Women's Leadership Center

Women's Leadership Center Conditional Use Permit Narrative: 18.1207.D(2)

Planning Request Application - Statements

L901

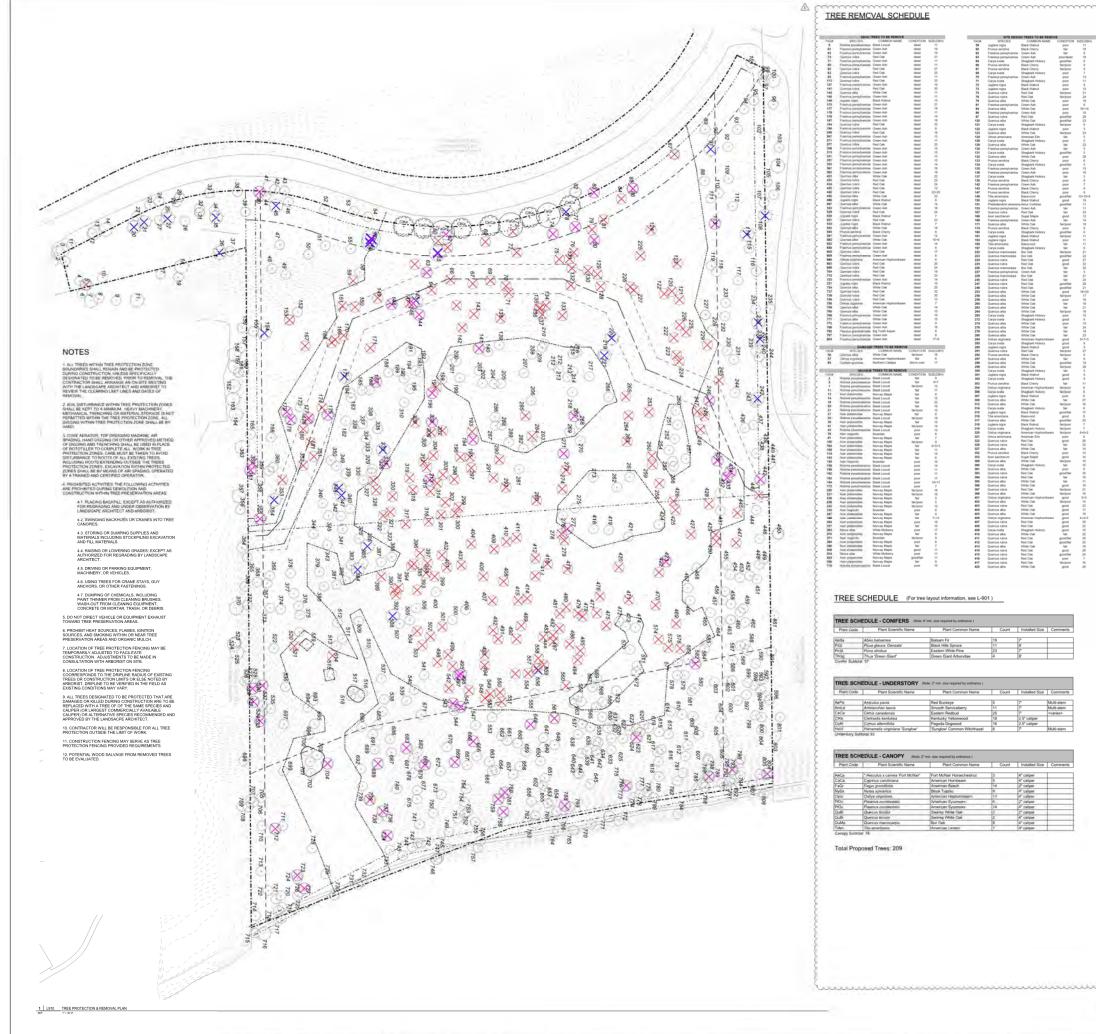
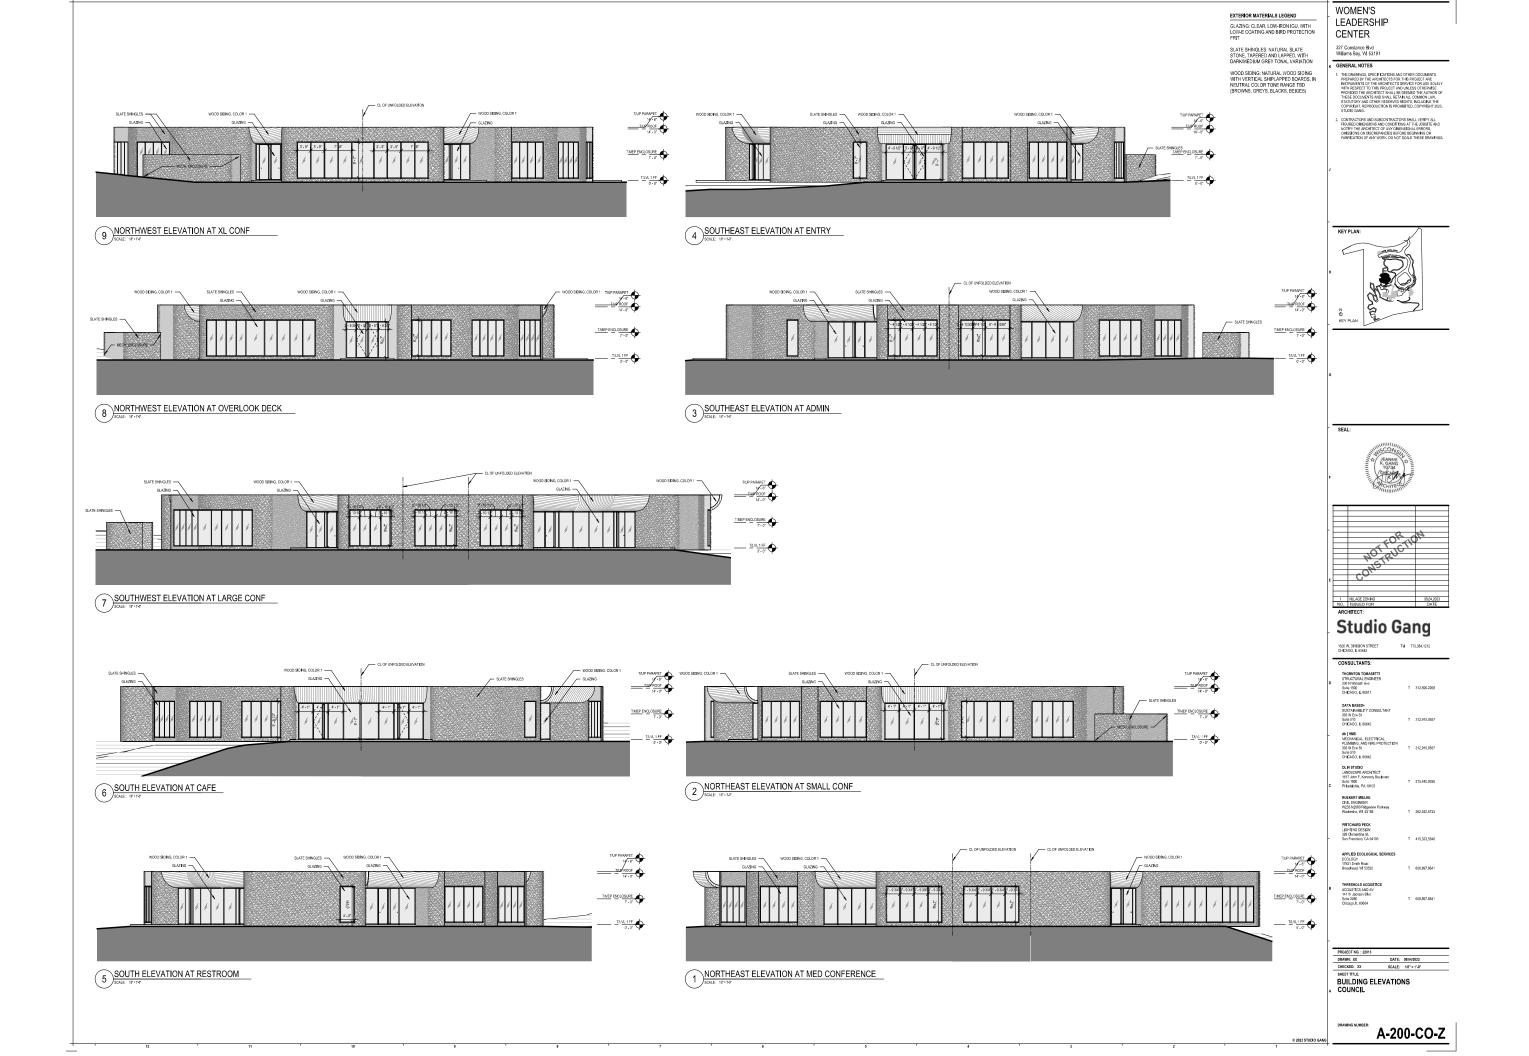
Response: Per zoning requirements for building foundation, our project is required to meet or exceed a minimum of 549 landscape points. We estimate that the design per plan would provide 3947 landscaping points. See calculations in chart on sheet L901.

Response: No shade trees are counted in the building foundation landscape points requirements calculation. Landscaping points achieved were calculated using only medium trees and shrubs, refer to the sheet L901.

Response: Per zoning requirements for street frontage, our project is required to meet or exceed a minimum of 309 landscape points. We estimate that the design per plan would provide 405 landscape points. See calculations in the chart on sheet L901.

Response: Per zoning requirements for paved areas, our project is required to meet or exceed a minimum of 264 landscape points and 951 square feet of landscape area. We estimate that the design per plan would provide 5031 landscaping points. See calculations in the chart on sheet L901.

Response: Per zoning requirements for buffer yard, our project on the east side is required to meet 0.4 opacity. We estimate that the design per plan would provide over 299 landscaping points per 100 linear feet requirements. See calculations in chart on sheet L901

C-500

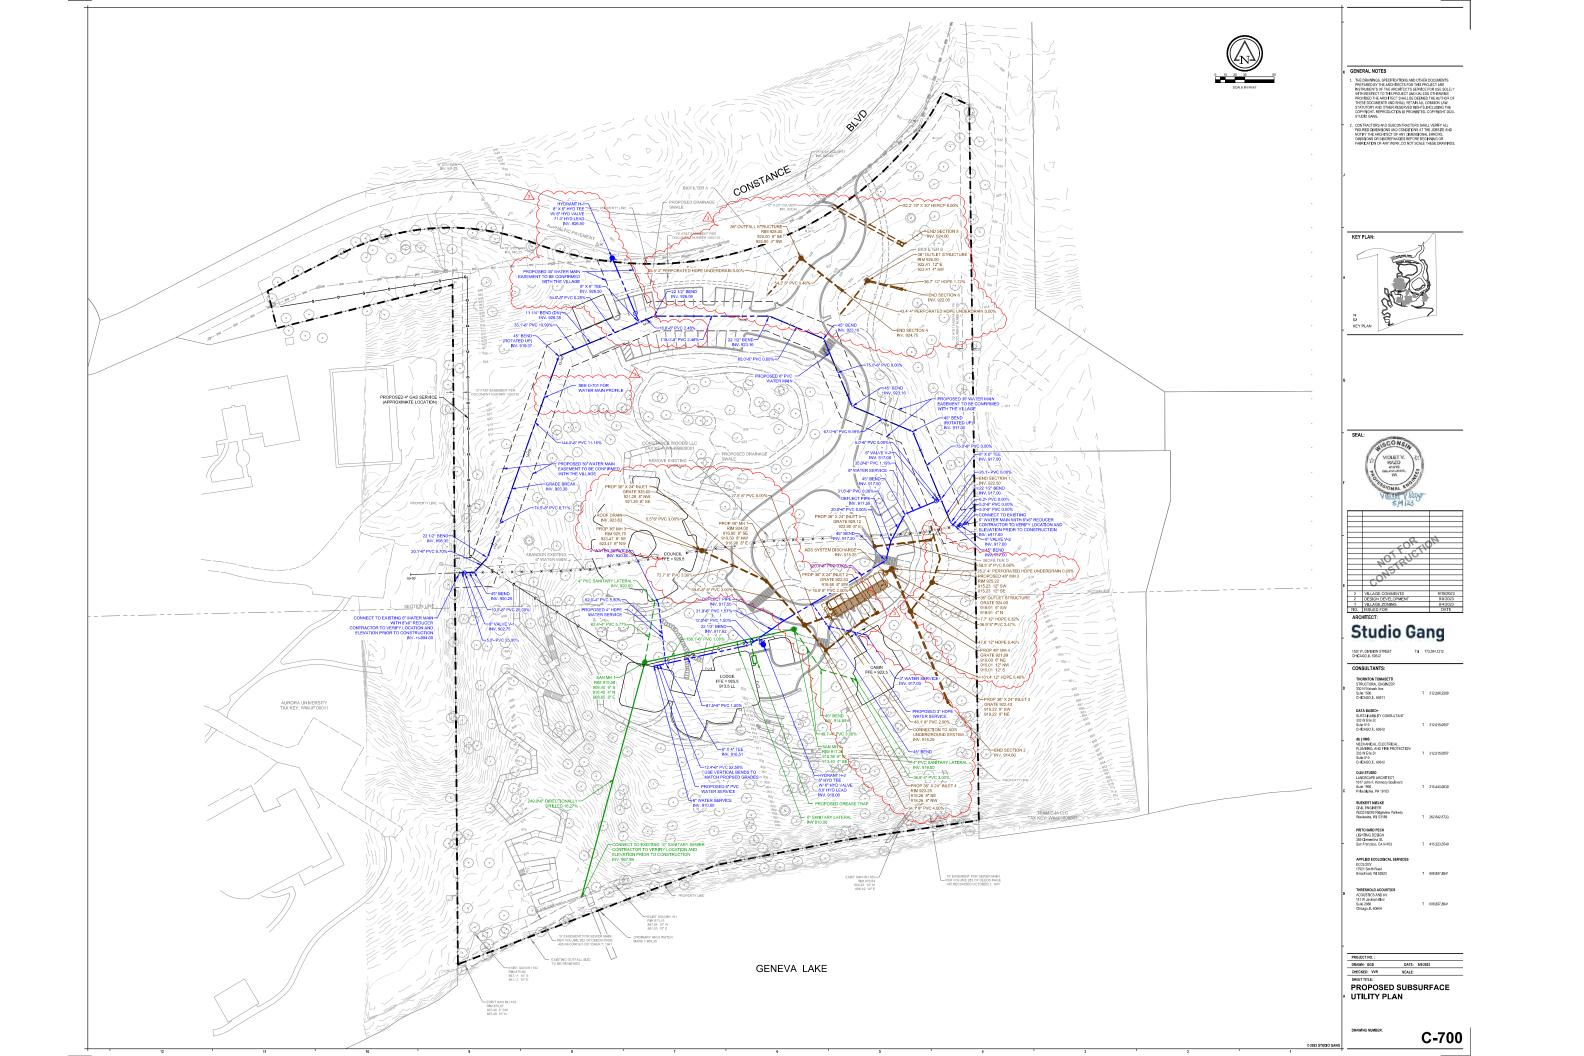
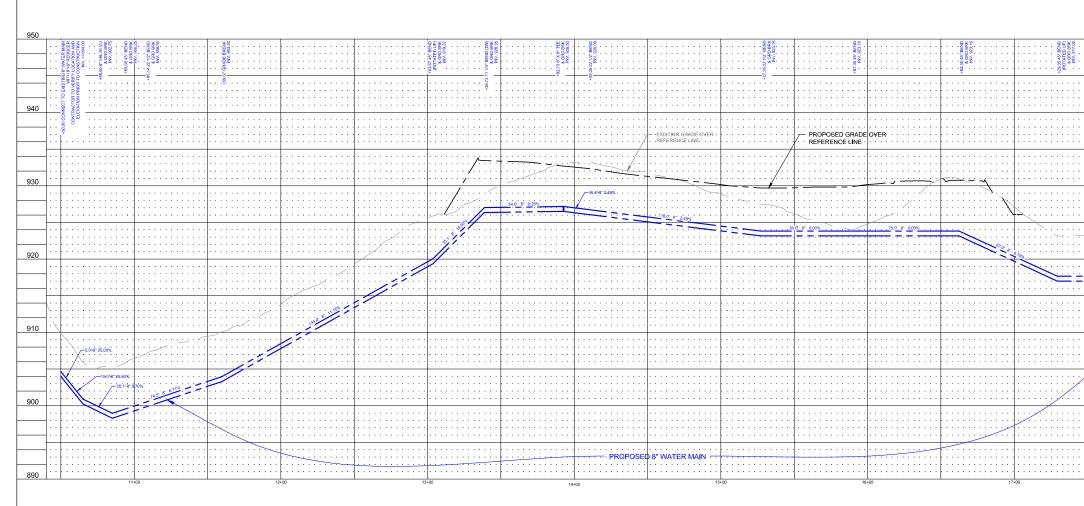
- d. Provide a copy of the WDNR water main extension permit when received. This will be provided when received.
- 2. Sheet C-500 (Grading & Erosion Control Plan):

- a. Show drainage divides. Drainage divides have been added to Exhibit 3 of the Stormwater Management Report.
 - b. Provide wider riprap/flow spreaders at pipe outlets to reduce channelized flow. Rip rap adjusted to be wider.

- f. Show large storm event overland flow paths. Black arrows have been added to Exhibit 3 of the Stormwater Management Report.
 - g. Provide project benchmarks. Project benchmarks have been added to plan sheet C-200 – Existing Conditions.

C-802

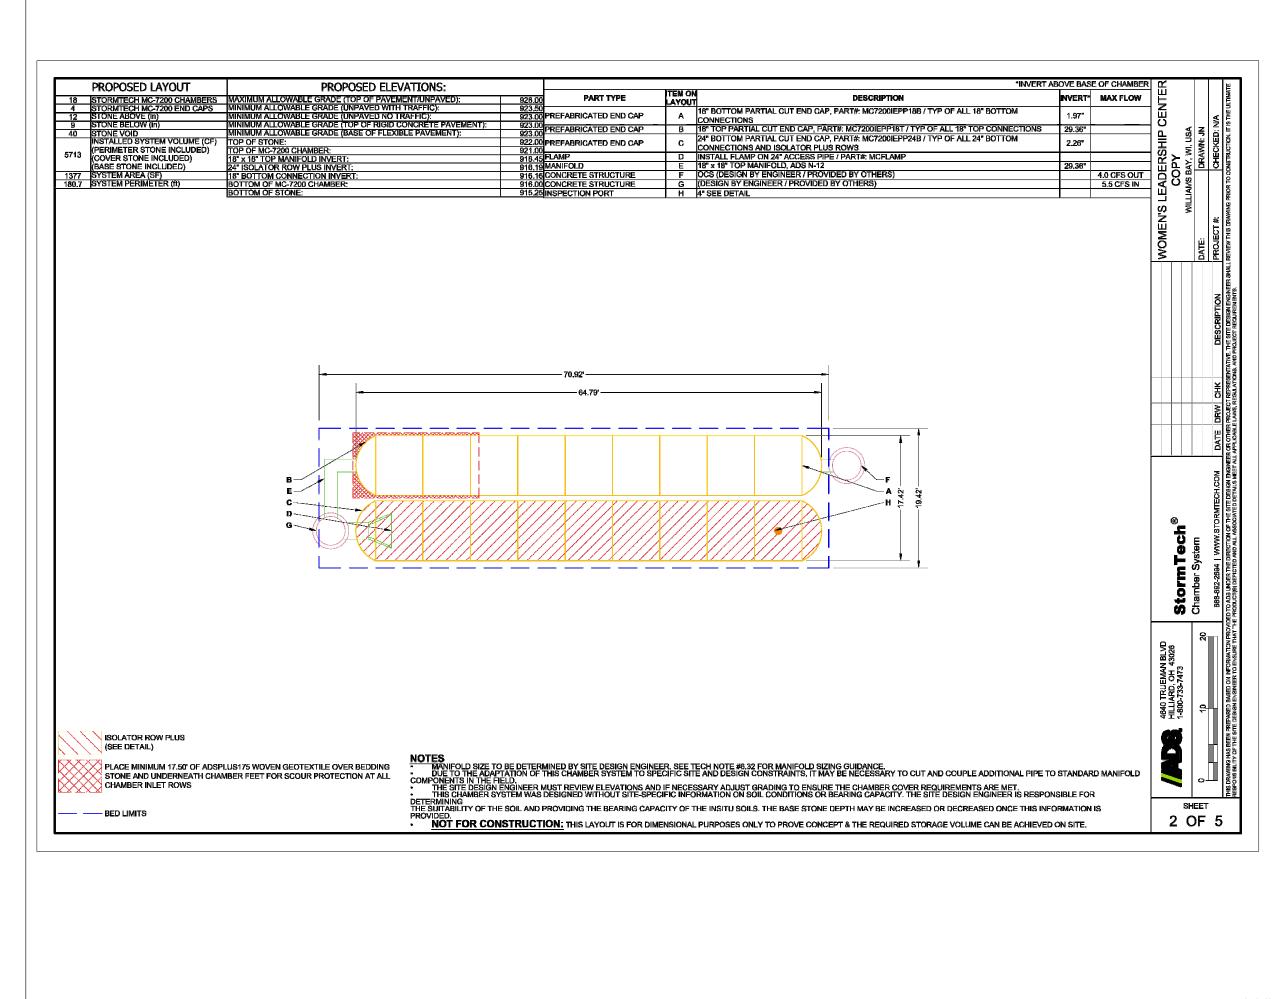
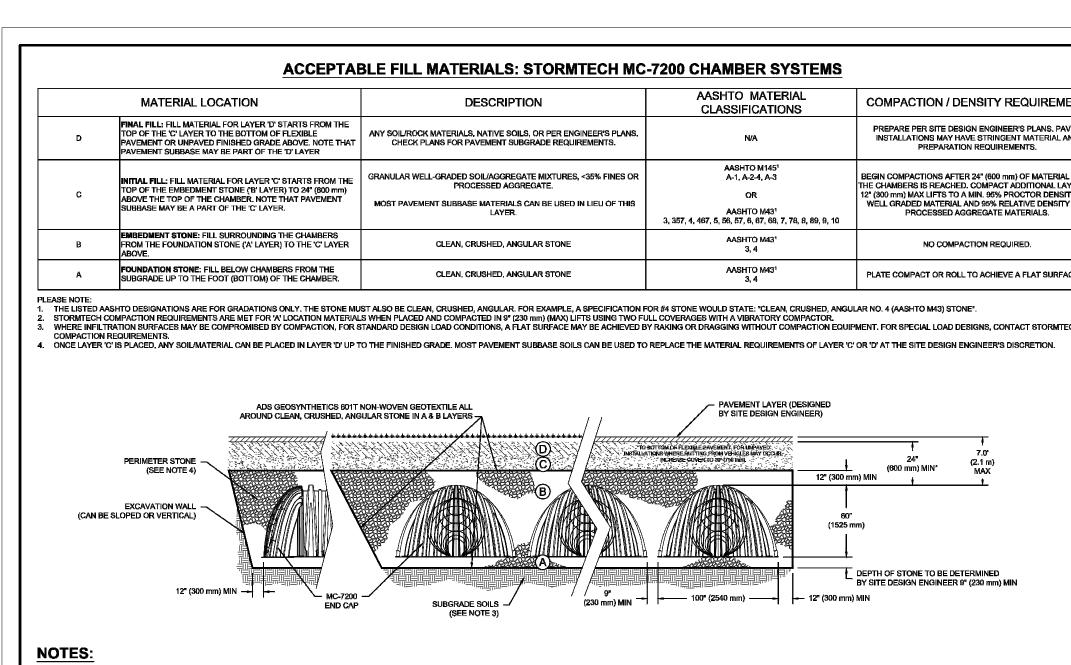
- Biofilter basins should be designed with underdrains and overflow structures to provide proper infiltration and TSS removal per WDNR Technical Standard 1004. They are serving no purpose with outlet pipes located above the floor of the basins.
 Underdrains have been added to all biofilters and Exhibit 4.
